Millstone Nuclear Power Station, Unit No. 2
Automatic Initiation of Auxiliary Feedwater

MAIN STEAM LINE BREAK ACCIDENT ANALYSIS - RETURN TO POWER

MAIN STEAM LINE BREAK ANALYSIS - CONTAINMENT PRESSURE

FIGURE 1

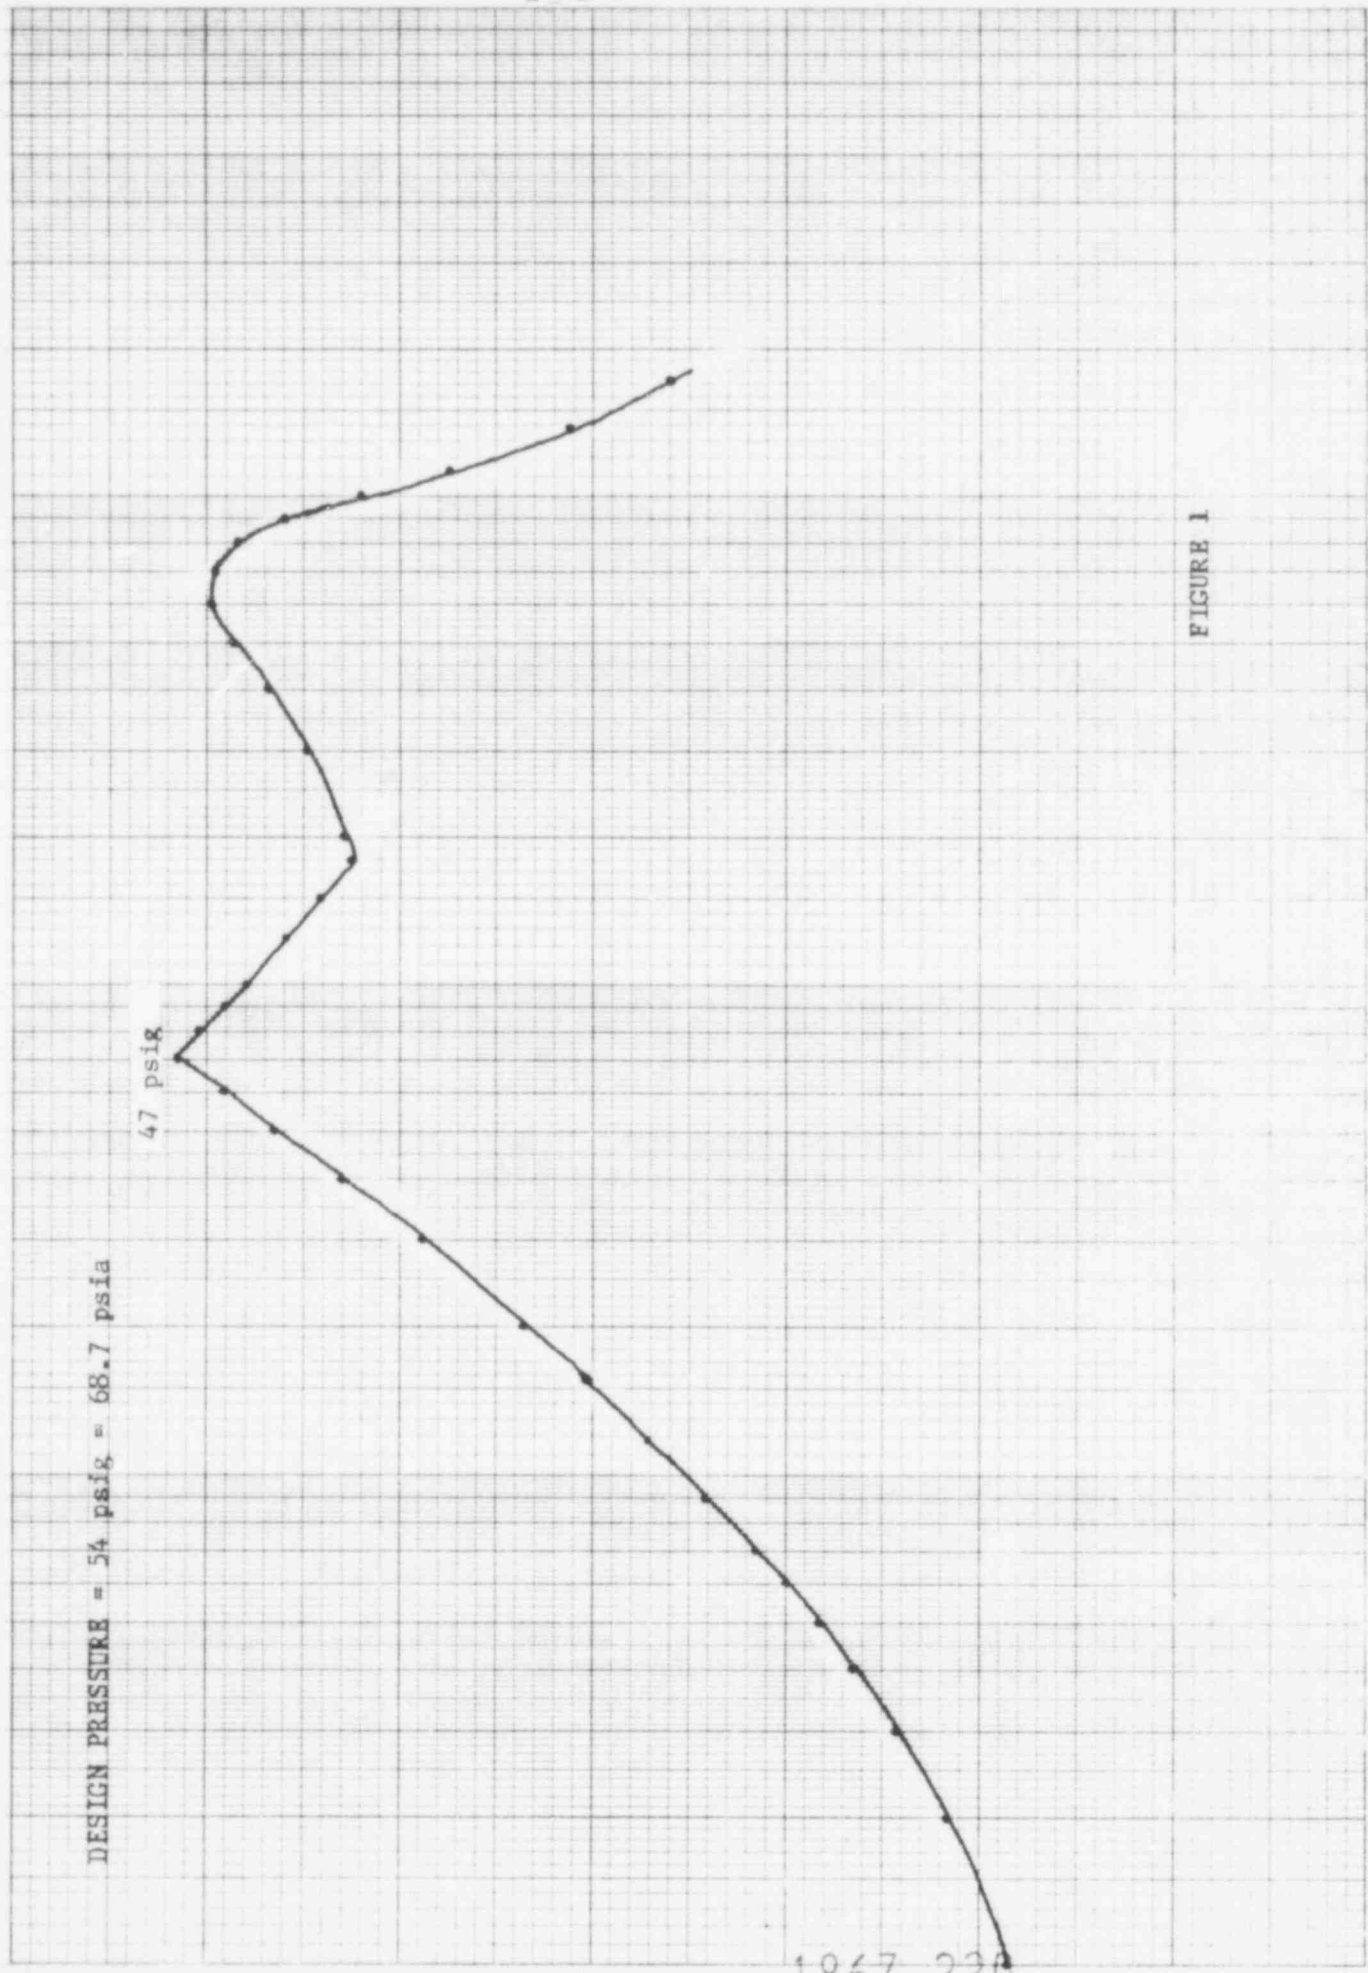
- f. For the single active failure case which results in the maximum containment atmosphere pressure, provide a chronology of events. Graphically, show the containment atmosphere pressure as a function of time for at least 30 minutes following the accident. For this case, assume the AFS flow to the broken loop steam generator to be at the pump run out flow (if a run out control system is not part of the current design) for the entire transient if no automatic isolation to auxiliary feedwater is part of the current design.

A chronology of events is shown in Table 1 for the limiting case, which is Case 1 described above.

The containment atmosphere pressure is plotted versus time in Figure 1.

CHARACTERISTIC CURVE

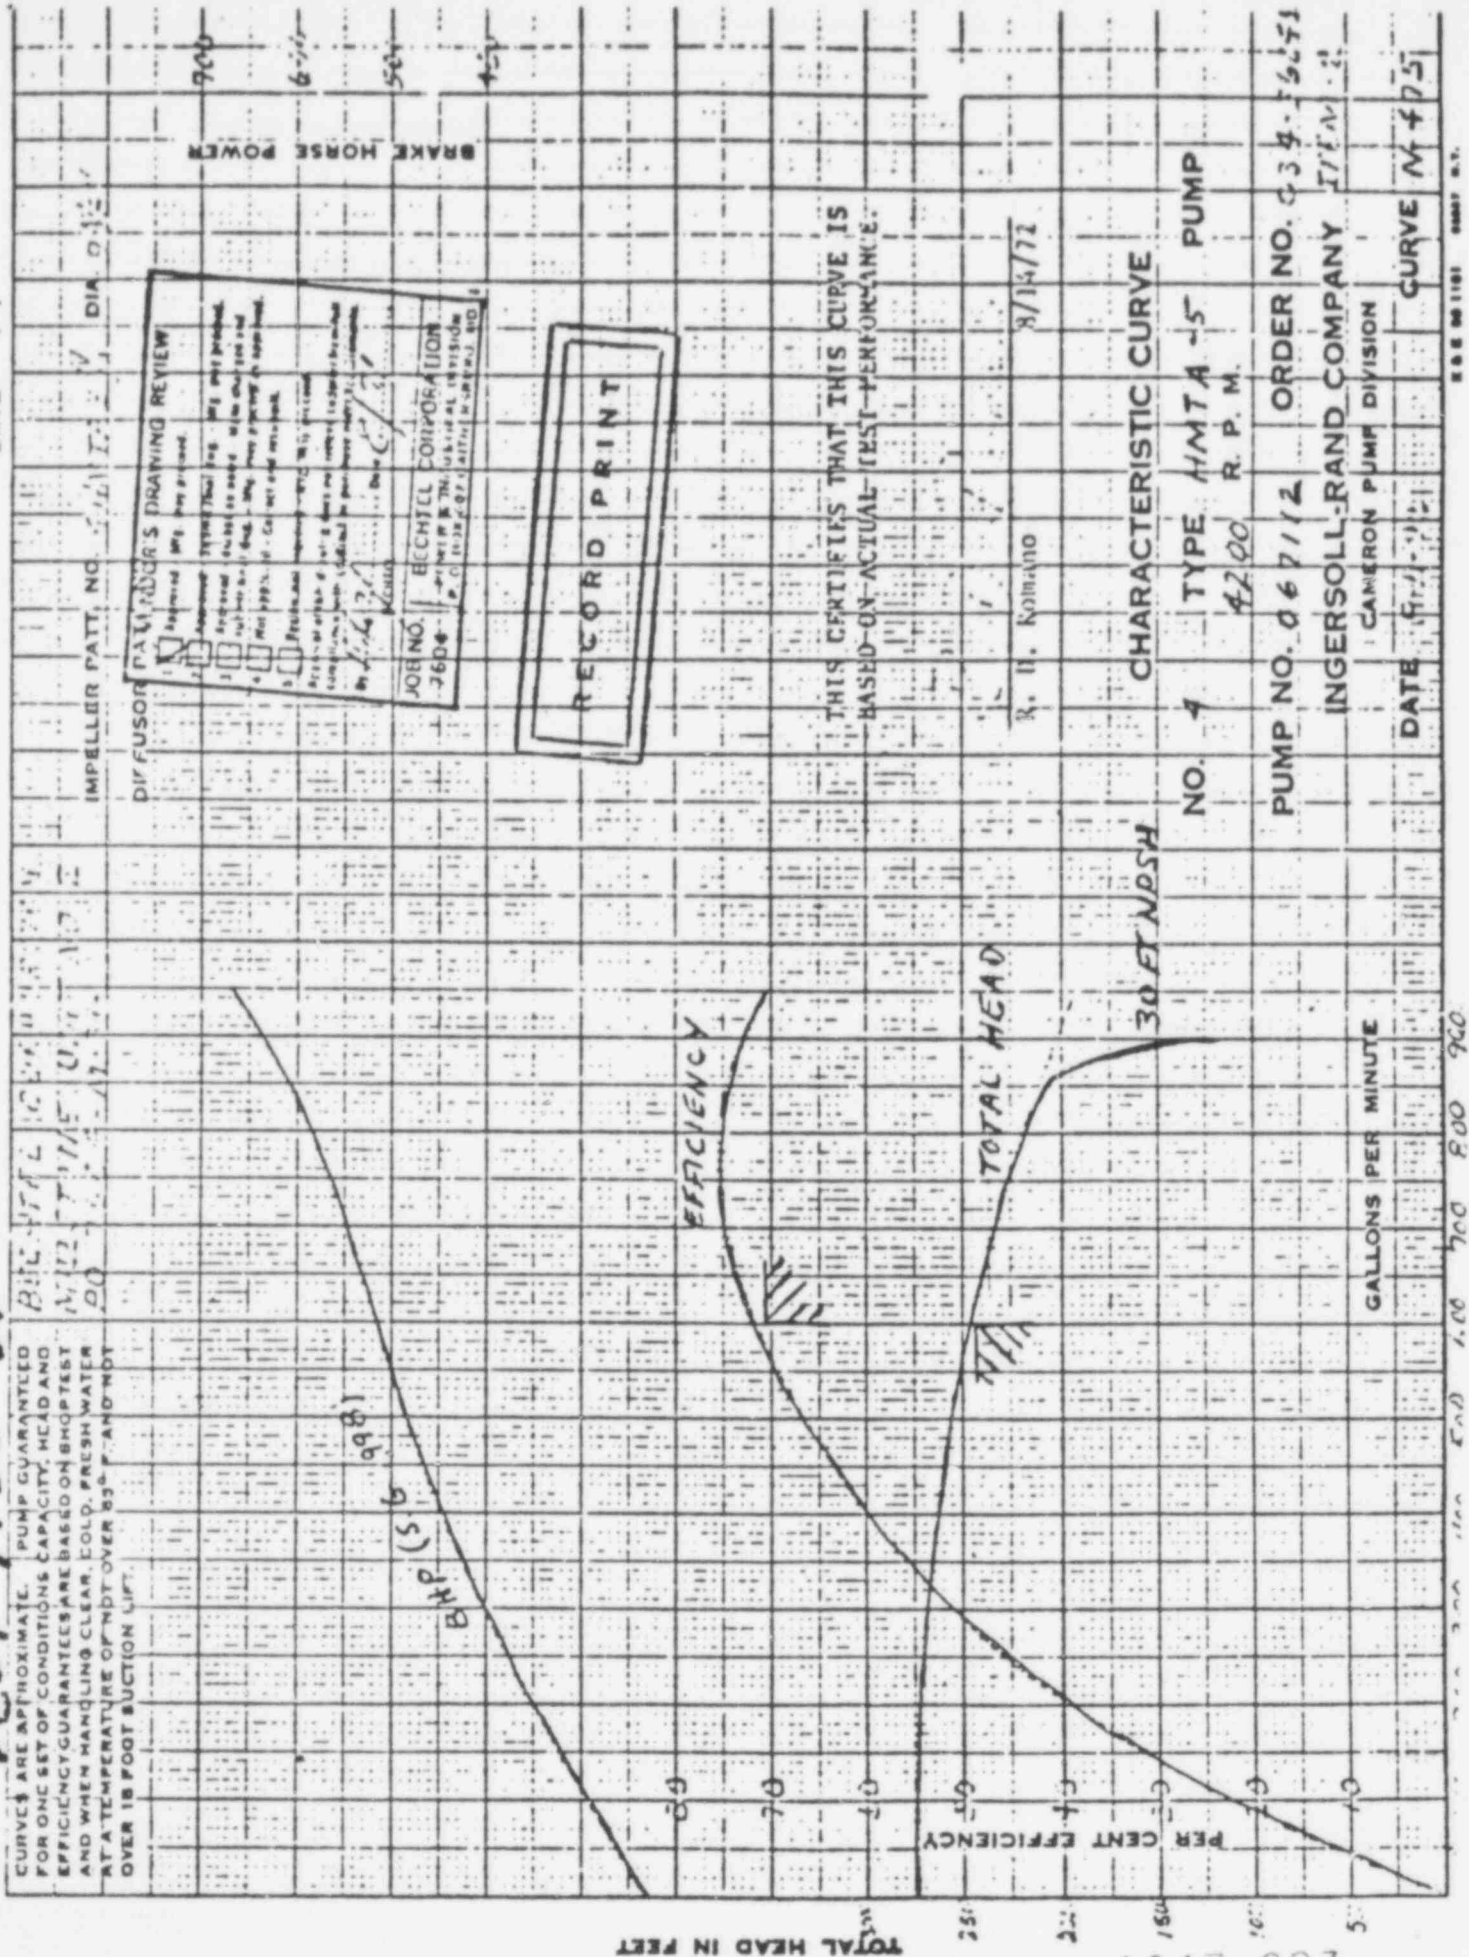
- b. Provide the rated flow rate, the run out flow rate, and the pump head capacity curve for your AFS design.

Millstone Unit No. 2 has one Steam Turbine Auxiliary Feedwater pump with a rated flow rate of 600 gpm plus 2 Electric Auxiliary Feedwater

pumps with rated flow rates of 300 gpm each. The total run out flow for all three pumps is 2050 gpm. Pump head capacity curves are also attached.
